ADDENDUM TO SOLICITATION/OFFER AND AWARD

1. ADDENDUM	2. EFFECTIVE DATE	3. SOLICITATION NUMBER	4. SOLICITATION DESCRIPTION
Two (2)	March 8, 2017	17-1	Reroofing Buildings 3, 6 & 9

ADDENDUM NO. 2
08 MARCH 2017
Reroofing Buildings 3, 6, & 9
FOR THE COLLEGE OF CENTRAL FLORIDA (ITB 17-1)
OCALA, FLORIDA

BUILDINGS 03 and 09 - ORIGINAL DETAIL

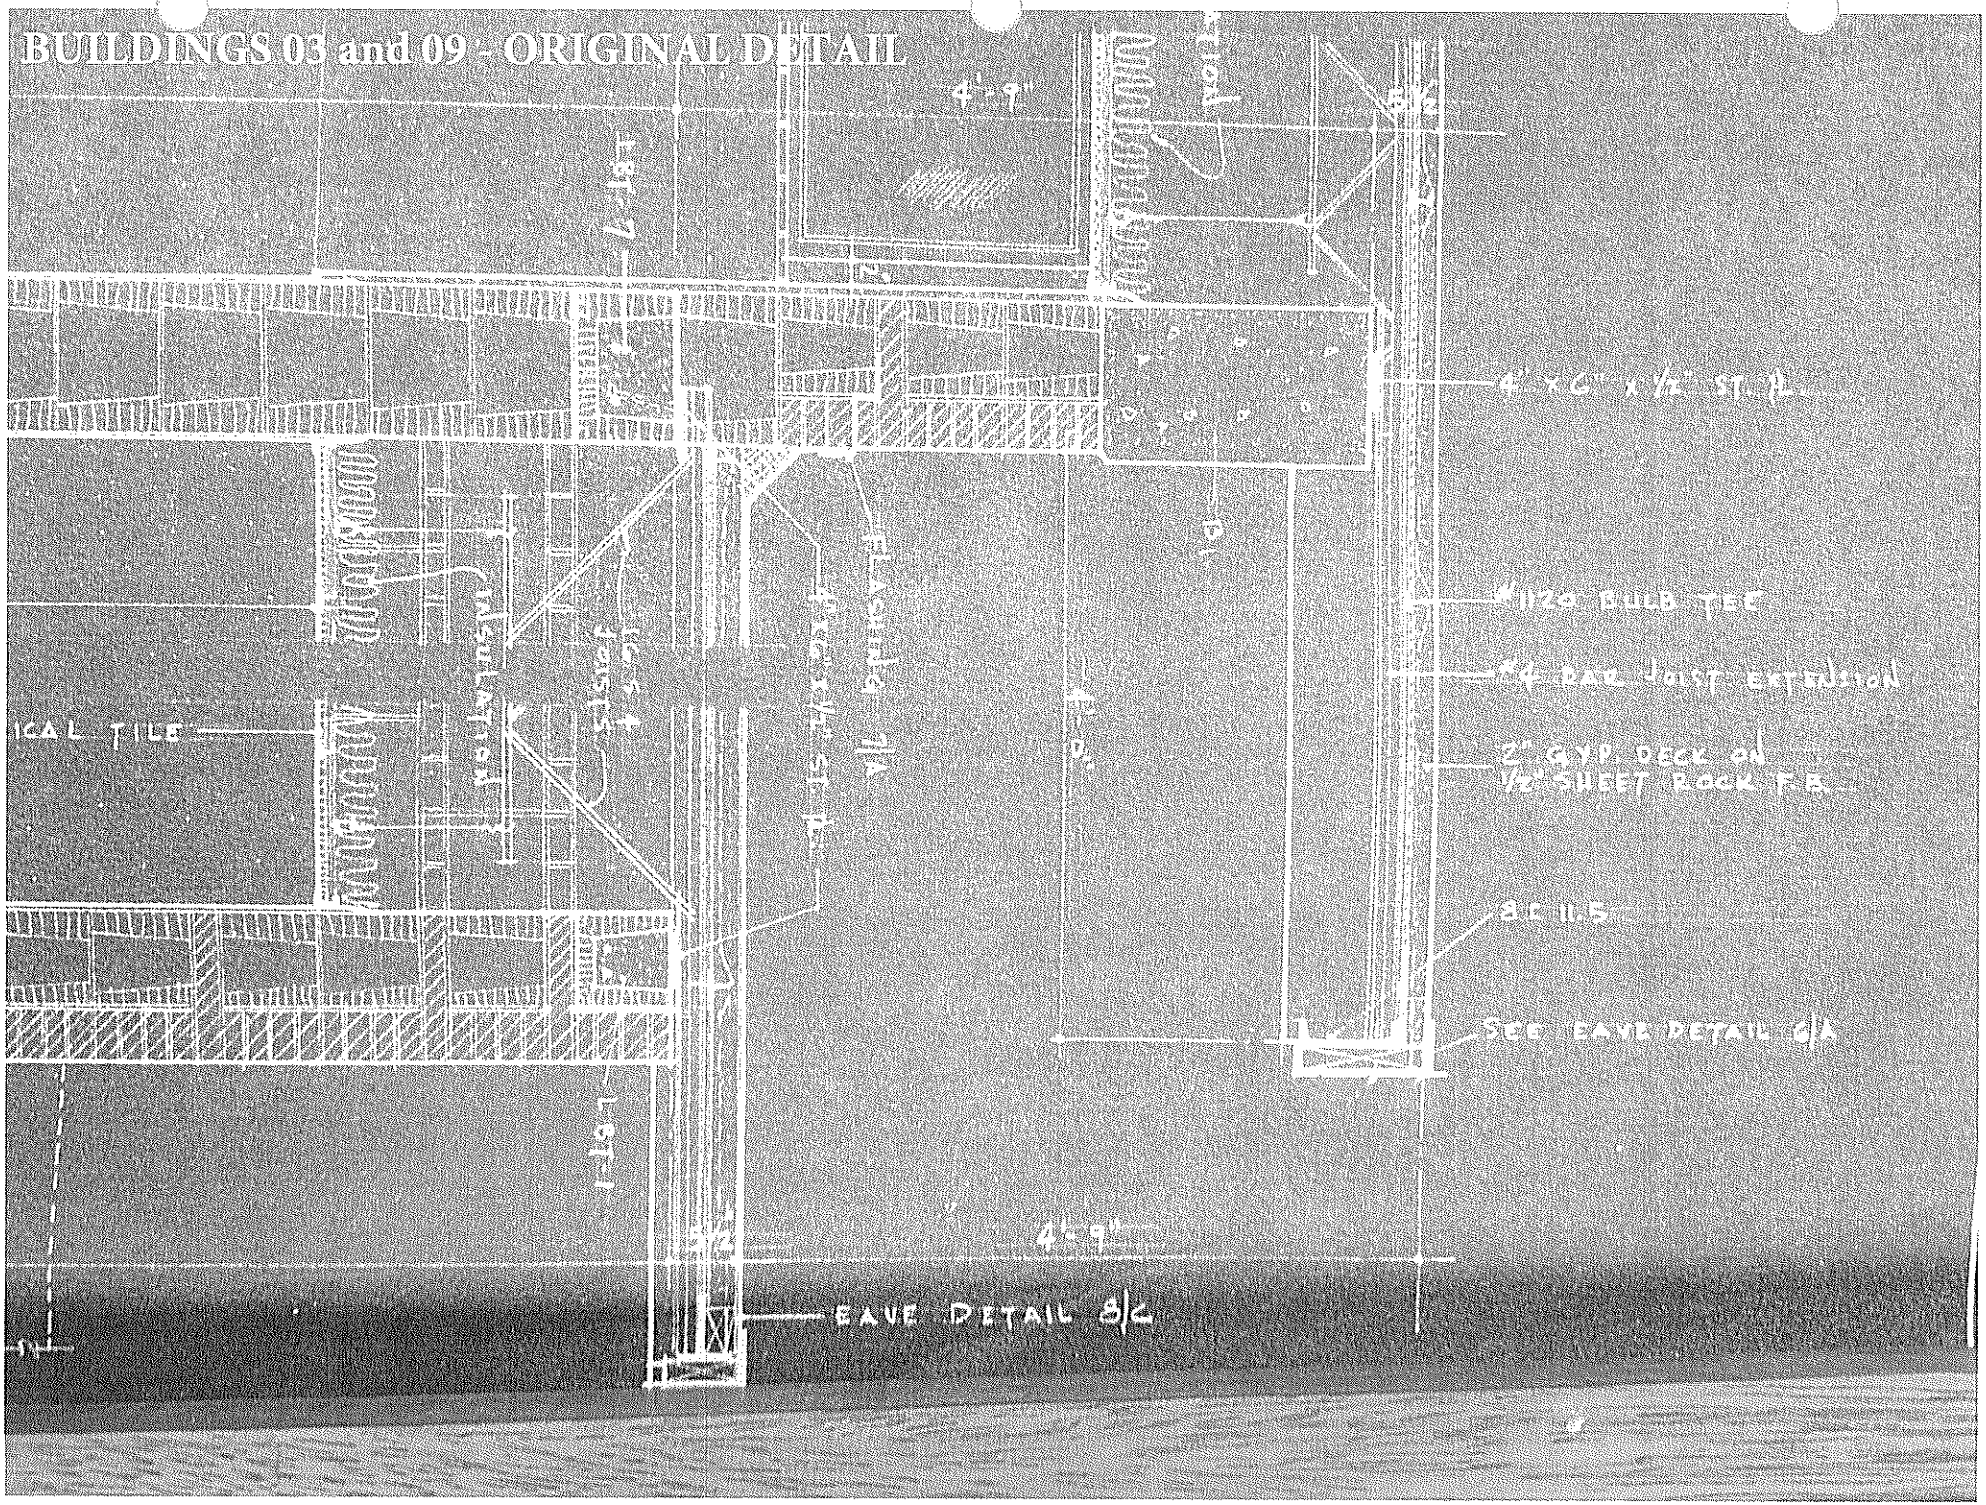
Item	Description	Reference
01	Simple Descriptions of each existing roof as requested (also shown on the drawings) 1. Building 03 and 09: Original roof deck is formboard and 2" pumped gypsum with a built-up roof per the original documents (original detail attached.) This system was covered by a roof-over with varying thicknesses WR Grace type foam insulation and lightweight concrete (thickness varies from 4" to 12") with a single ply WR Grace type membrane product. a. The intent of the documents is to remove all roof components and expose the oldest surface of the gypsum roof deck, replacing damaged deck, and adhering a new rigid tapered insulation system with a white PVC membrane product. 2. Building 06: Original roof deck is cementitious fiber (tectum) roof deck (original detail attached). This system was covered by a roof over with a constant thickness WR Grace type foam insulation and lightweight concrete (thickness is approximately 8") with a single ply WR Grace type membrane product. a. The intent of the documents is to remove all roof components and expose the surface of the tectum deck, replacing damaged deck, and adhering a new rigid insulation system with a white PVC membrane product.	Clarification

BUILDING 06 - ORIGINAL DETAIL

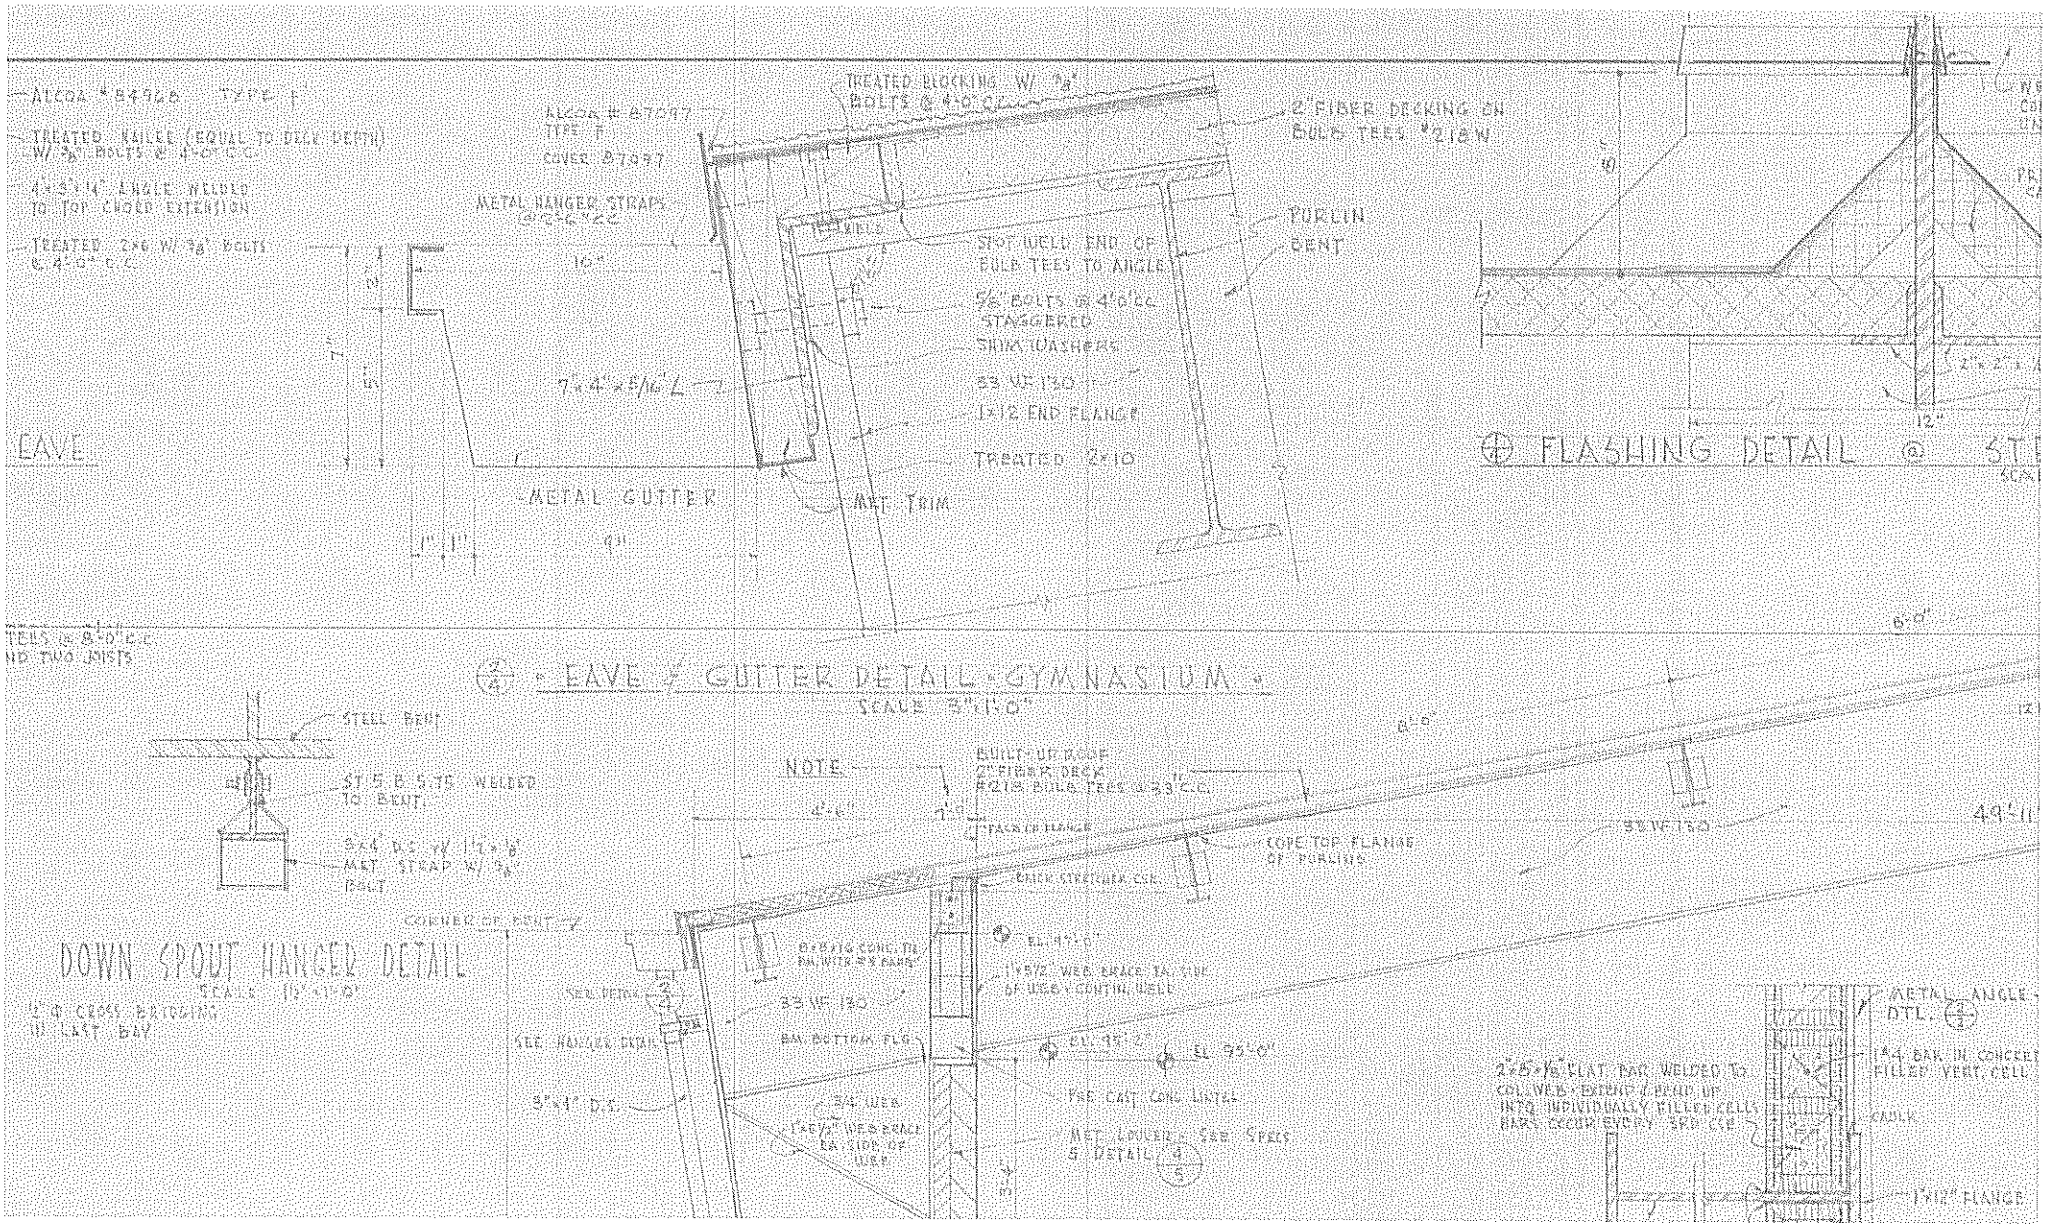
02	Building 06: Original roof deck is cementitious (tectum) fiber deck. A second deck was added later with rigid insulation and lightweight concrete that must be removed. The deck repair allowance is for the original cementitious (tectum) deck.	Clarification

Building 3 - Roof Plan

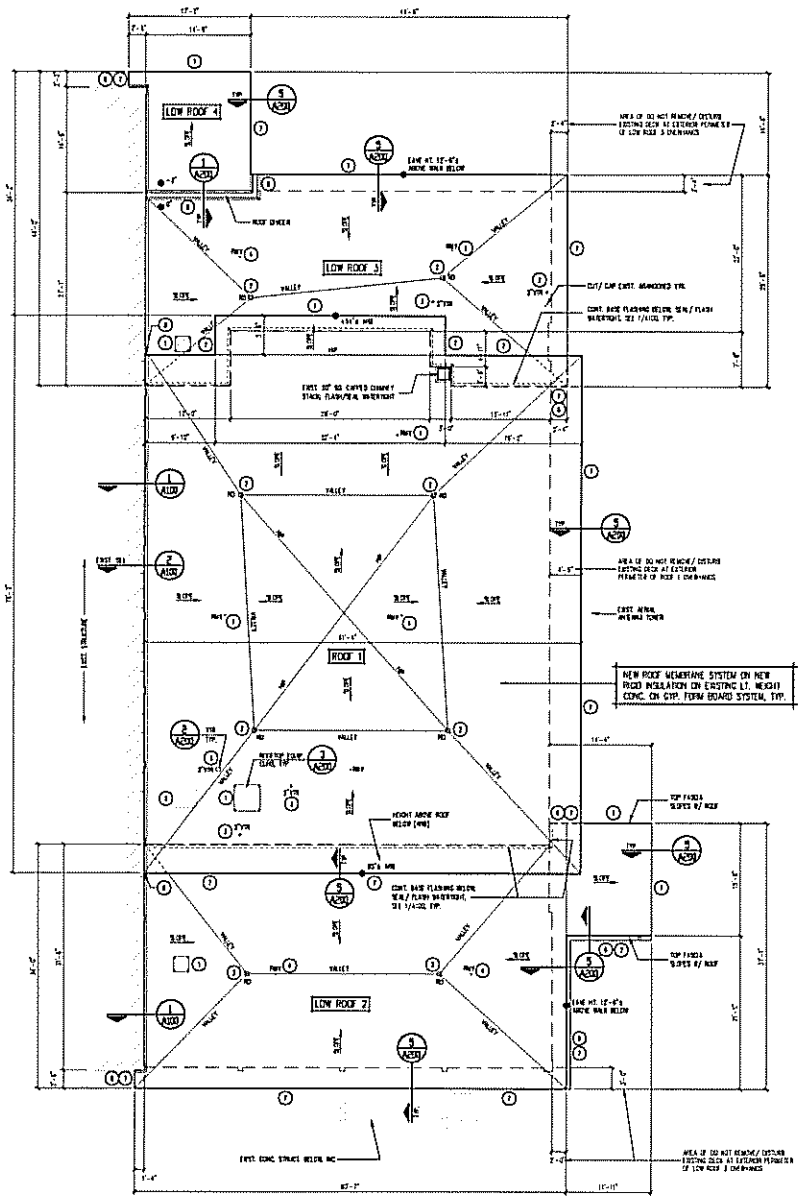
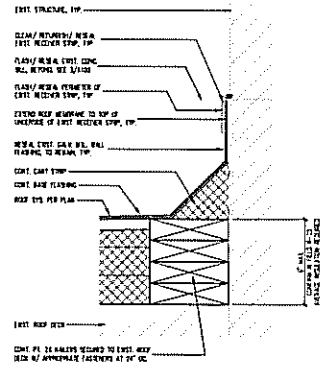
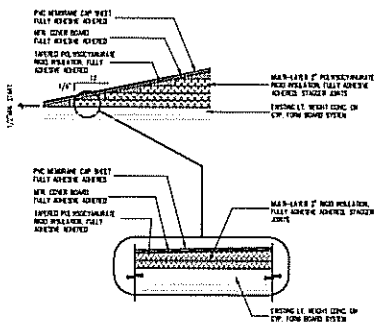
08	Building 03 Sheet A100: Original roof deck is pumped gypsum on formboard. A second deck was added later with rigid insulation and lightweight concrete that must be removed. The deck repair allowance is for the original gypsum and formboard deck (revised Sheet A100 attached).	Drawing A100 Building 03
09	Building 06 Sheet A001 special project note #10 requires periodic inspections by the roofing system manufacturer. Daily inspections are not required by the roofing system manufacturer. Spec Section 07540 3.06B requires daily inspections by the owner's on-site building inspector (clarification).	Drawings A001 Building 06
